**RE: Montoya Street Townhomes (File: H12D019A)
Tracts A1 and A2 Lands of David Maciel
Montoya St NW between Floral Rd and I-40
Grading Plan and Drainage Report
Engineer's Stamp Date – 12/16/2015**

RE: **Montoya Street Townhomes (File: H12D019A)**
Tracts A1 and A2 Lands of David Maciel
Montoya St NW between Floral Rd and I-40
Grading Plan and Drainage Report
Engineer's Stamp Date – 10/15/15

REVISED
DRAINAGE REPORT

Montoya Street Townhomes
Lots 1-5 Maciel-David Subdivision
Albuquerque, New Mexico

ENGINEER'S SEAL  10/15/13 DMD SCALE P.C. #14522	MONTOLYA STREET TOWNHOMES GRADING AND DRAINAGE PLAN  1000 SOUTH AVENUE, SE SUITE 201 ALBUQUERQUE, NM 87105 DMD P.C. #14522	DRAWN BY: MCMU
		DATE 10-15-15 SHEET # 21523

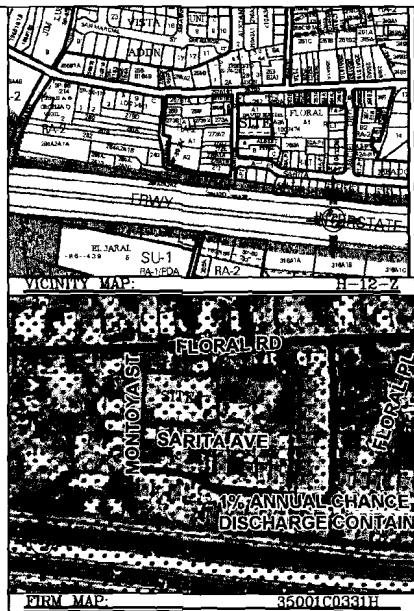
- Provide drainage flow areas to better identify overall site drainage patterns. **ADDED BASIN MAP**
- Provide roof flow direction and outfall locations. **ADDED TO PLAN**

- Clearly identify and define property lines. **"**
- Clearly identify the location and limits of the 10 ft Ditch Easement located on the north property line. **"**

- The Drainage Report indicates flows from a storm event exceeding the 100-yr, 6 hr storm event will discharge to Montoya Street. Per the spot elevations identified on the Grading Plan, it appears flows will be directed east away from Montoya Street. Show on the Grading Plan how this will be achieved. **REVISED REPORT TO CORRECT**

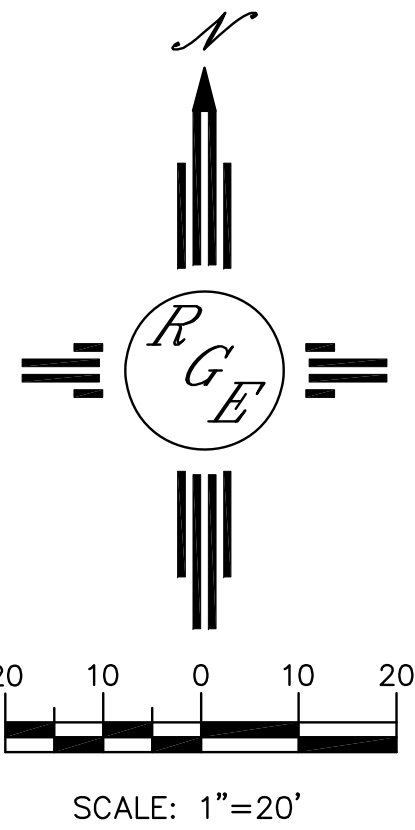
- The Drainage Report states the platting action will allow for cross lot drainage easement on all parcels yet the Drainage Report identifies flows to be retained onsite or discharged onto Montoya Street during a larger design storm. Provide offsite flow information and how offsite flows will be managed onsite. **ADDED BASIN MAP**

- A scale check on the area for townhomes 1-5 appears as though the area provided is incorrect. Re-check the areas to ensure the information is correct. **CORRECTED**
